PCN – Process Change Notification

Change:	MA605 series
Date:	2017/12/18
Author	Haley Tsai

Model#	Part Number	Changes
Spartan Screwmount GPS/GLO/GALILEO - SMA(M)3M RG174/ Cellular-SMA(M)3M CFD- 200/WiFi-RP-SMA(M) 3M CFD-200	MA605.A.ABC.001	1. Amend P/N to MA605.A.ABC.001. 2. Amend 2.4/5 GHz label to 2.4/5.8 GHz label. 3. Amend labels' material to PEPA. 4. Add barcode label. 5. Amend 147.5mm to 147.31mm in width. 6. Amend 65.35mm to 69mm in height. 7. Amend tolerance of 18.5mm from +/-0.3mm to +/-0.5mm. 8. Remove package from the EDW drawing. 9. Add foam model type.
Spartan Screwmount GPS/GLONASS- SMA(M)5M RG174/ Cellular-SMA(M)5M CFD- 200/ WiFi-RP-SMA(M) 5M CFD-200	MA605.A.ABC.004	
Spartan Screwmount GPS/GLONASS- TNC(M)3M RG174/Cellular- SMA(M)3M CFD-200/ WiFi-RP-SMA(M) 3M CFD-200	MA605.A.ABC.005

Illustration of Change

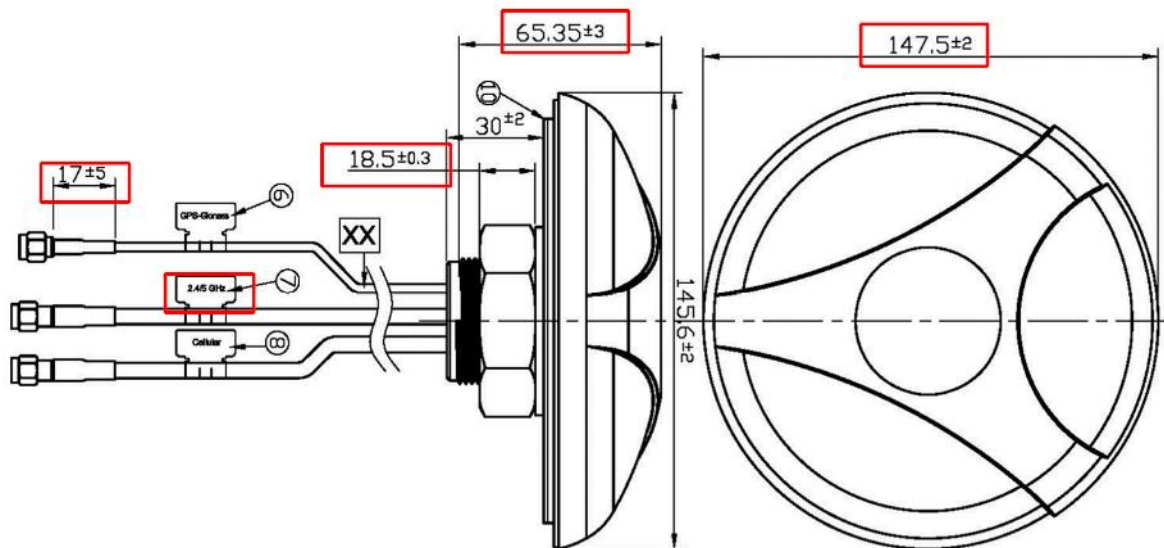
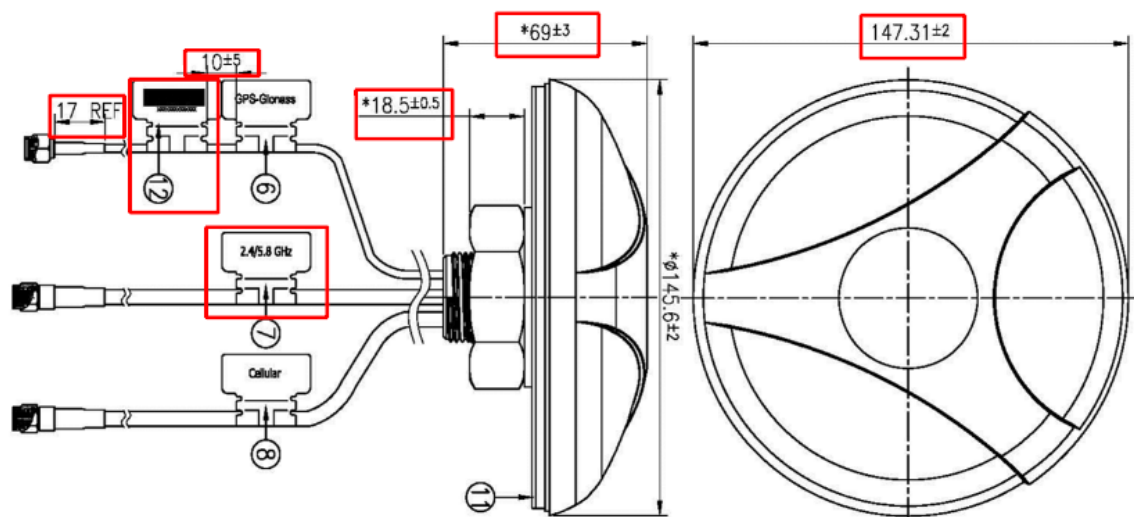
1. Amend P/N to MA605.A.ABC.001. SAP P/N: MA605.A.ABC.001.
2. Amend 2.4/5 GHz label to 2.4/5.8 GHz label.
3. Amend labels' material to PEPA.
4. Add barcode label.
5. Amend 147.5mm to 147.31mm in width.
6. Amend 65.35mm to 69mm in height.
7. Amend tolerance of 18.5mm from +/-0.3mm to +/-0.5mm.
8. Remove package from the EDW drawing.
9. Add foam model type.

6	GPS-Glonass Label	001012K010015A	PEPA	Orange	1
7	2.4/5.8 GHz Label	001016G070000A	PEPA	Teal Green	1
8	Cellular Label	001013B010015A	PEPA	Blue	1
9	Heat Shrink Tube	001315C020000A	PE	Black	1
10	Heat Shrink Tube	001315C030000A	PE	Black	2
11	Double Sided Adhesive(Black Foam)	001011F030015A	3M 9448HK+CR4305 2t	White Liner	1
12	Barcode Label	001013G000015A	PEPA	White	1
